# **City of Bloomington Common Council**

## **Legislative Packet Addendum**

**Bloomington Common Council Ordinance No. 2026-06 to Amend the City of Bloomington Zoning Maps by Rezoning a 6.3 Acre Property from Residential Urban Lot (R4) and Residential Multifamily (RM) within the Transform Redevelopment Overlay (TRO) to Planned Unit Development (PUD) and to Approve a District Ordinance and Preliminary Plan**

Attached is the staff report which pertains to Plan Commission case Z02025-12-0018. The Plan Commission heard this petition at the February 9, 2026 hearing and voted 8-0 to send this petition to the Common Council with a favorable recommendation.

# PUD PHASING

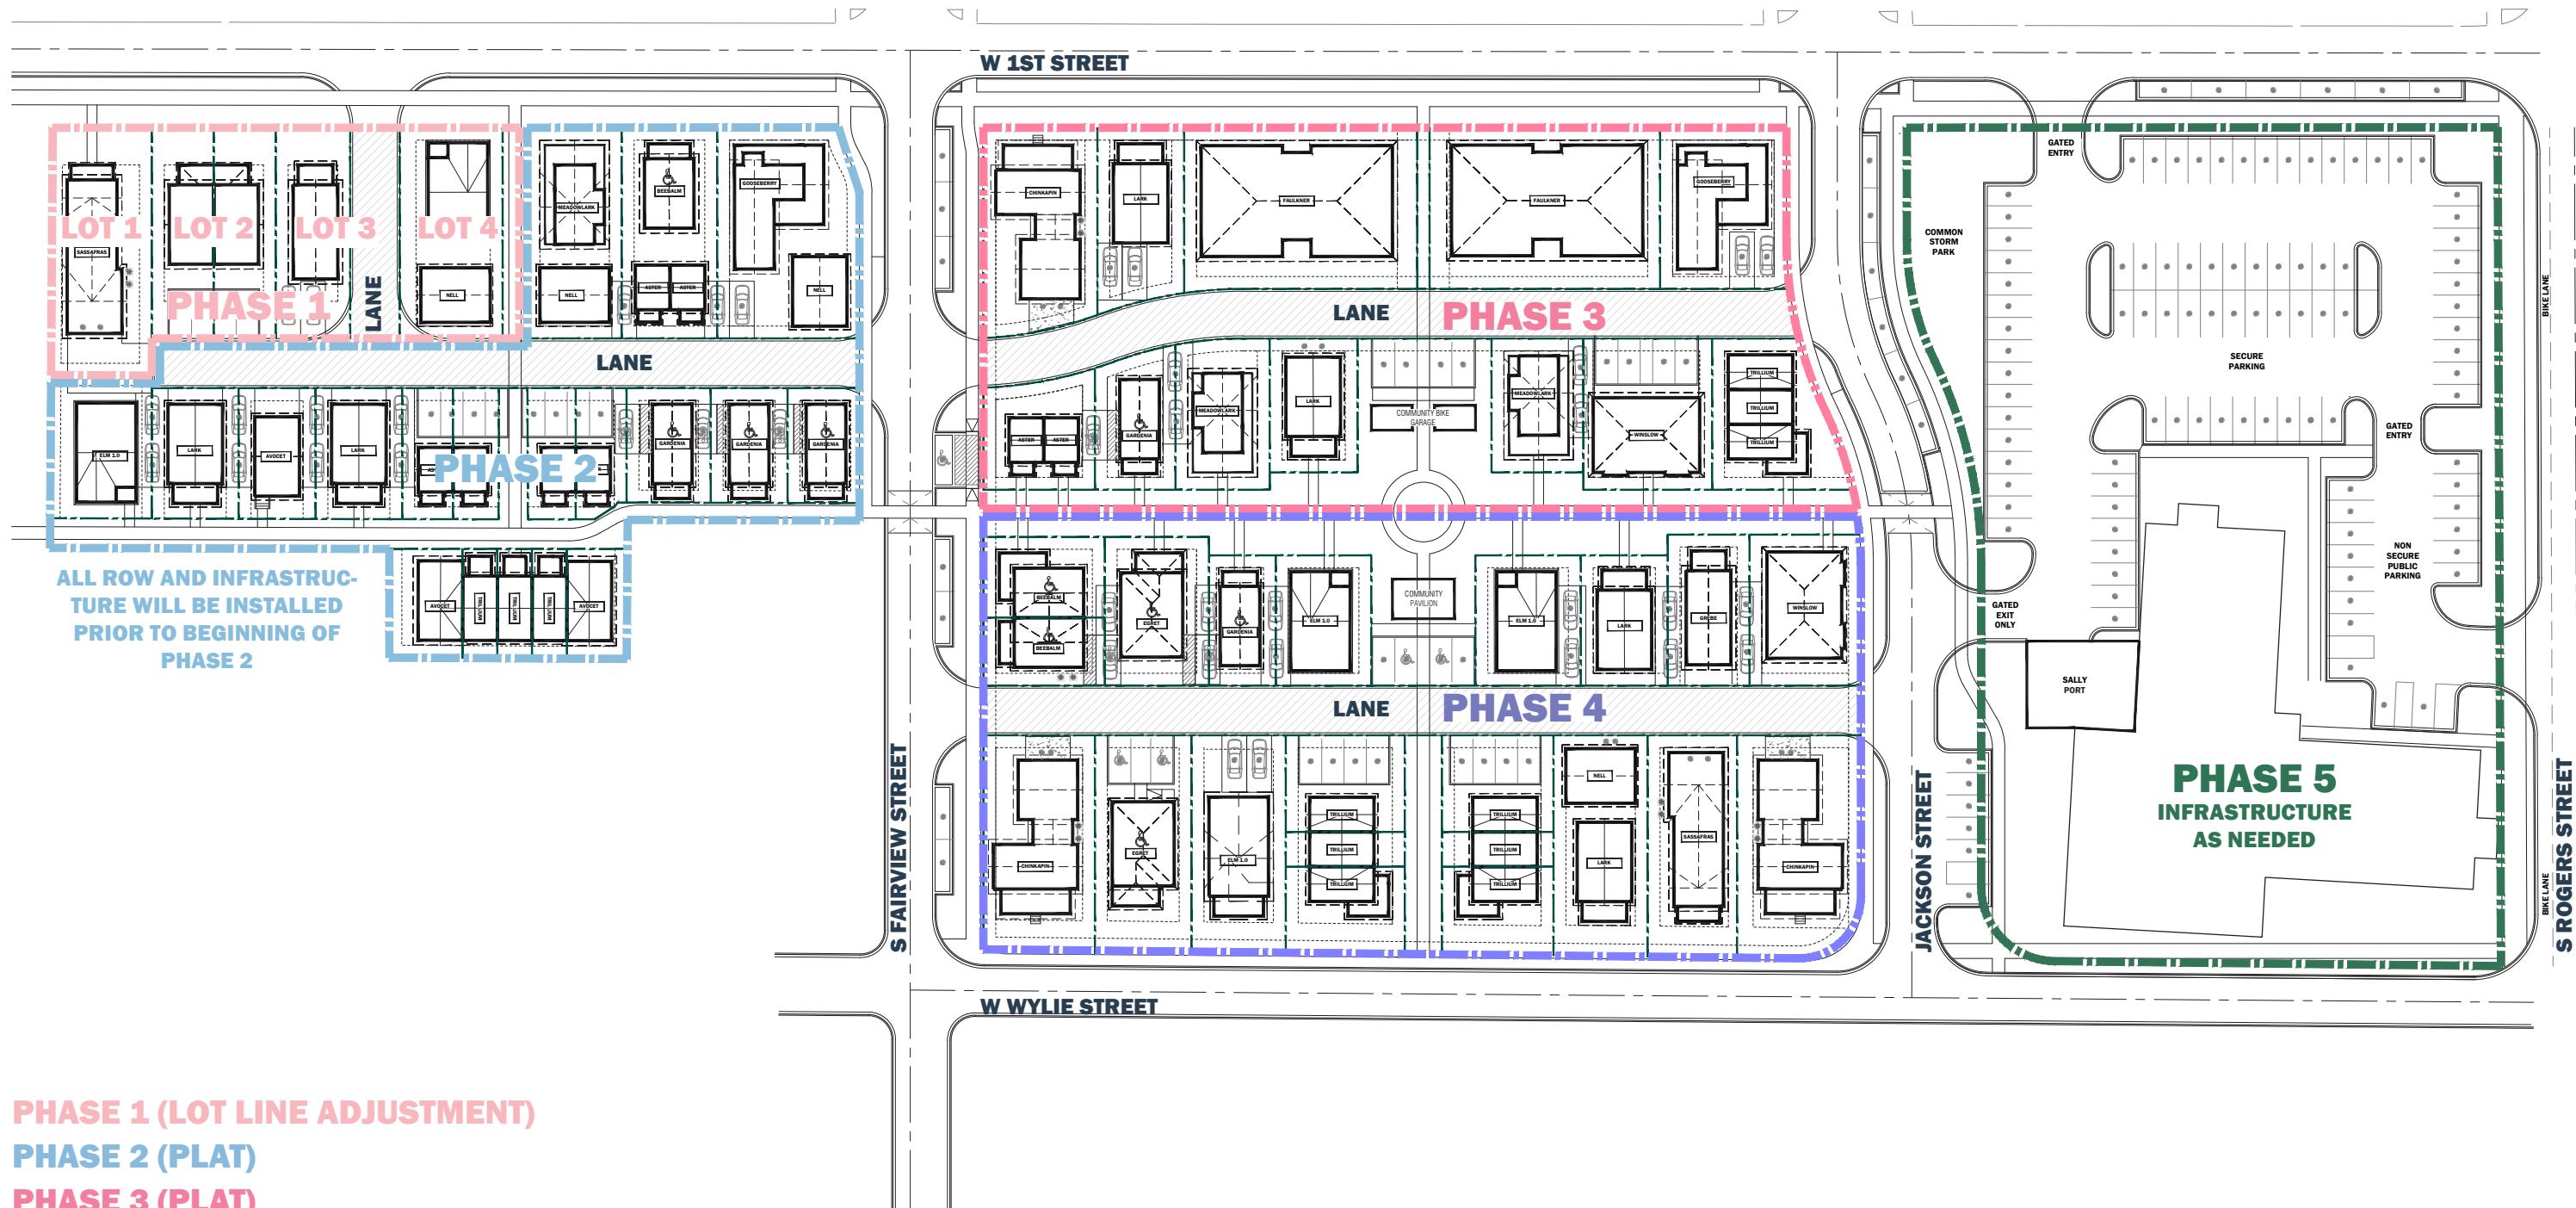
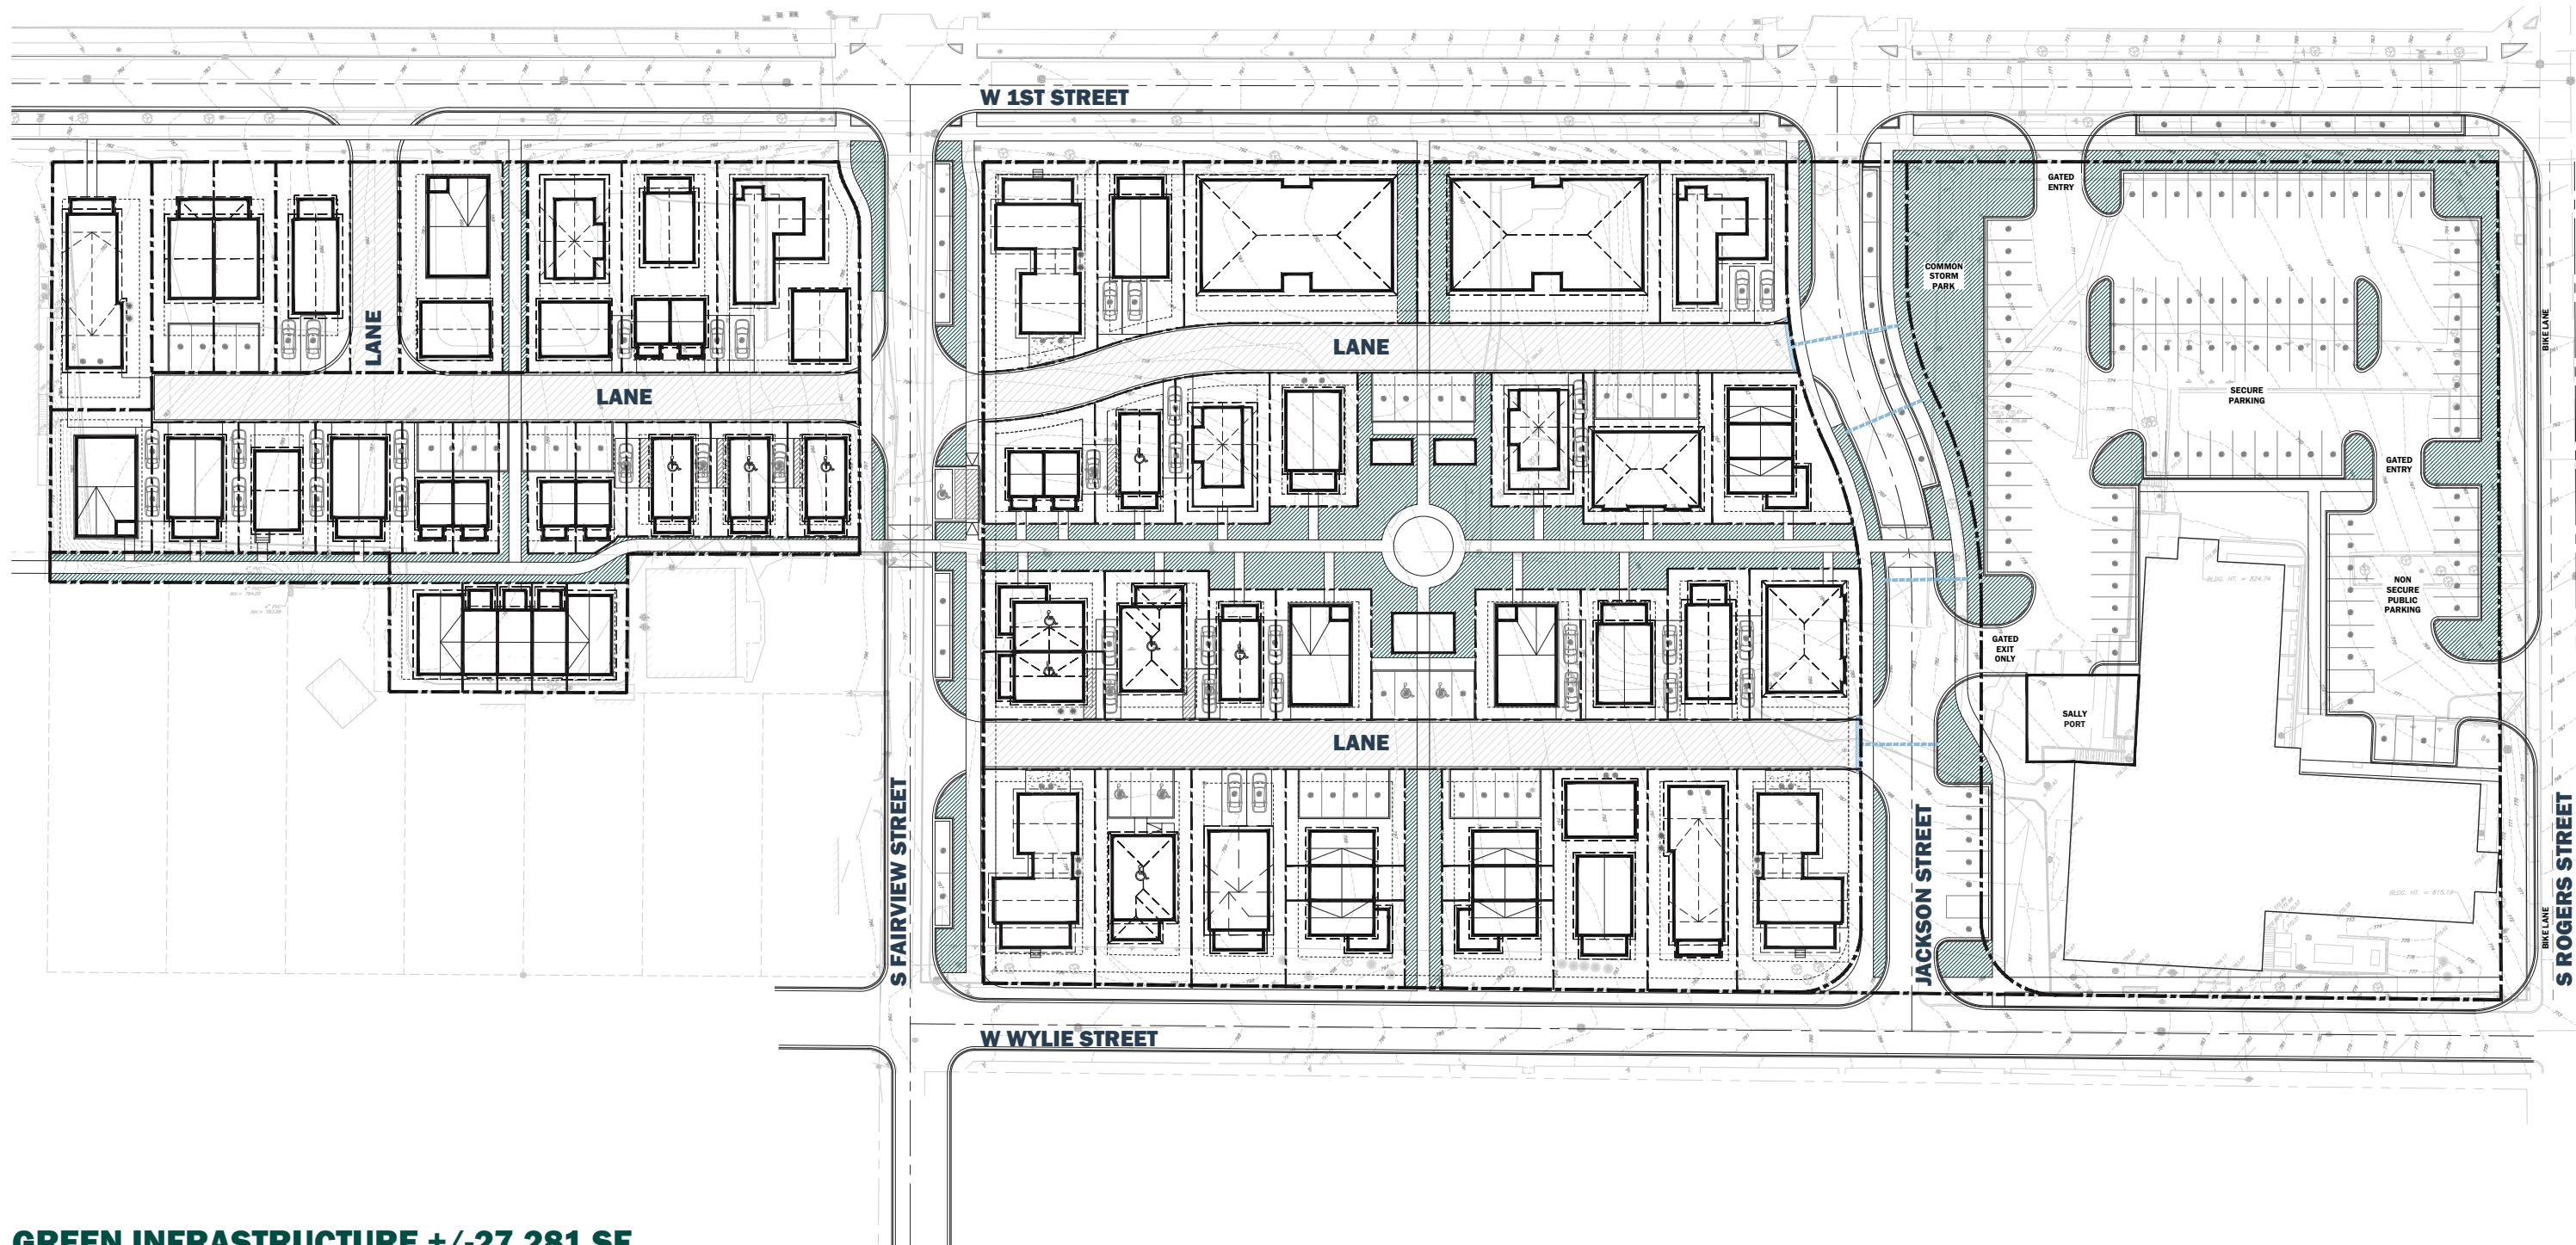
The proposed phasing plan shows three overall phases that would include adjusting existing lot lines to allow the creation of smaller individual lots along the west side of the site and subsequently followed by a primary plat for the development. The phasing plan is still unclear on when specific internal streets and infrastructure for the overall development will be installed as development occurs. The Public Works and Fire Department have indicated a need for Fairview Street to be constructed with the initial plat in order to serve the new units that are accessed exclusively from the proposed Lane. The Utilities Department has also indicated a need for a phasing plan to be presented outlining the plans for stormwater detention and utility infrastructure within the development in conjunction with the primary plat. A condition of approval has been included requiring a phasing plan for infrastructure be submitted with the primary plat or final plan approval, whichever comes forward first.

A detailed phasing plan regarding specific infrastructure will be reviewed with subsequent approvals. This is essential to determining what infrastructure must be included with each plat and to adequately serve the overall PUD as it develops. A condition of approval has been included to require a detailed phasing plan with the primary plat or final plan, whichever comes forward first. The adjustment of lot lines will not be a trigger for final plan approval or require the detailed phasing plan with that aspect.

7. Within Parcel A, drivecuts shall be prohibited on 1<sup>st</sup> Street, Fairview Street, Wylie Street, and Jackson Street as indicated on the final plan for Parcel A.
8. All secondary plats shall be delegated to staff.
9. A specific phasing plan for all infrastructure including roads, utilities, and detention must be submitted and approved with either the final plan or primary plat approval, whichever comes forward first. The adjustment of lot lines will not require final plan approval or trigger a phasing plan.
10. Prior to final plan or primary plat approval, the petitioner shall prepare and include in the project record written documentation describing how visitability and accessibility were evaluated and how people with disabilities were engaged.
11. Petitioner will work with staff and Commissioner Stosberg to clarify language and correct citations in the District Ordinance.

1ST STREET

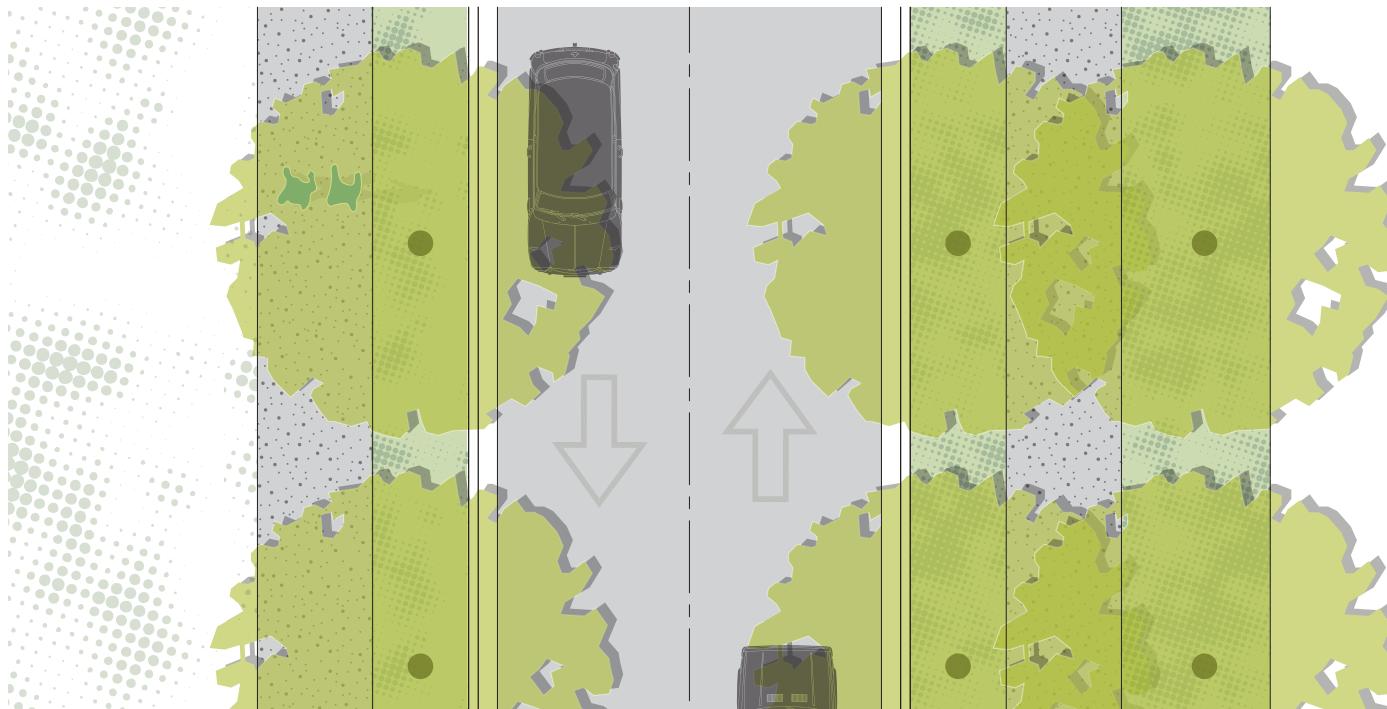
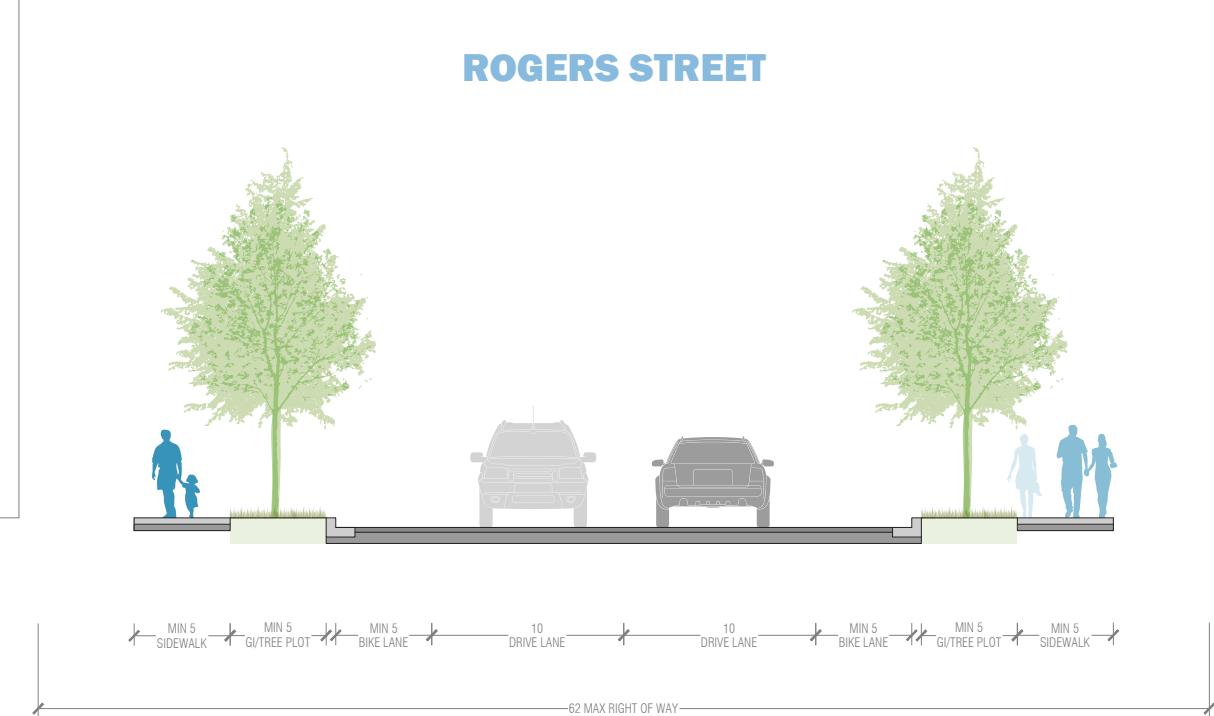
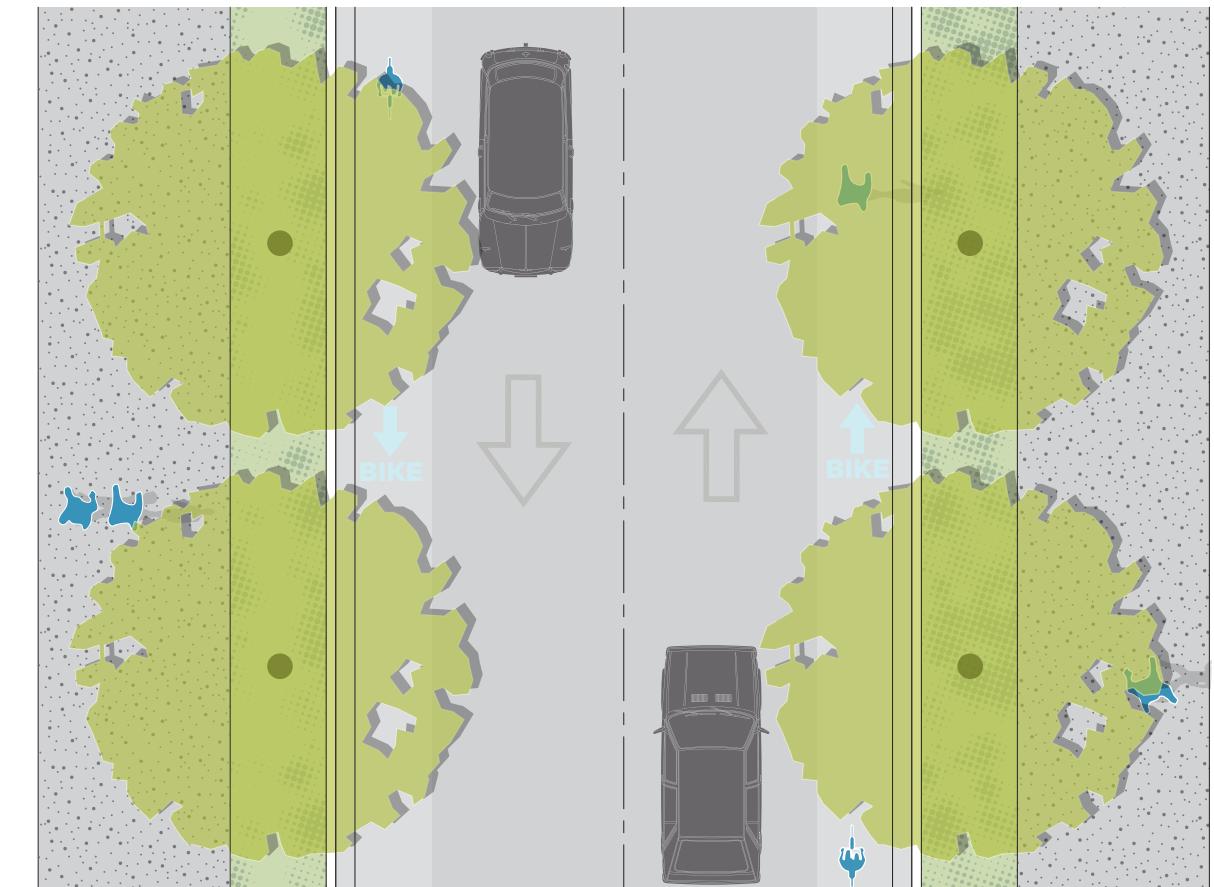
- Rogers Street
  - The Transportation Plan would require a total 84' of right-of-way (42' from centerline). There is currently approximately 20-25' of right-of-way from centerline. The proposed cross section within the PUD for Rogers Street shows a dedication of 31' from centerline for right-of-way.
    - Within this cross section there would be an allowance for the

- 1<sup>st</sup> Street
  - The Transportation Plan would require 60' of right-of-way and that currently exists, therefore no new right-of-way must be dedicated. In addition, the City recently completed a road improvement project for 1<sup>st</sup> Street along this frontage and installed all necessary improvements that include a 6' wide sidewalk and 5' tree plot with street trees along this frontage. No on-street parking was installed along the 1<sup>st</sup> Street corridor, including along this PUD frontage. No improvements along 1<sup>st</sup> Street are required.
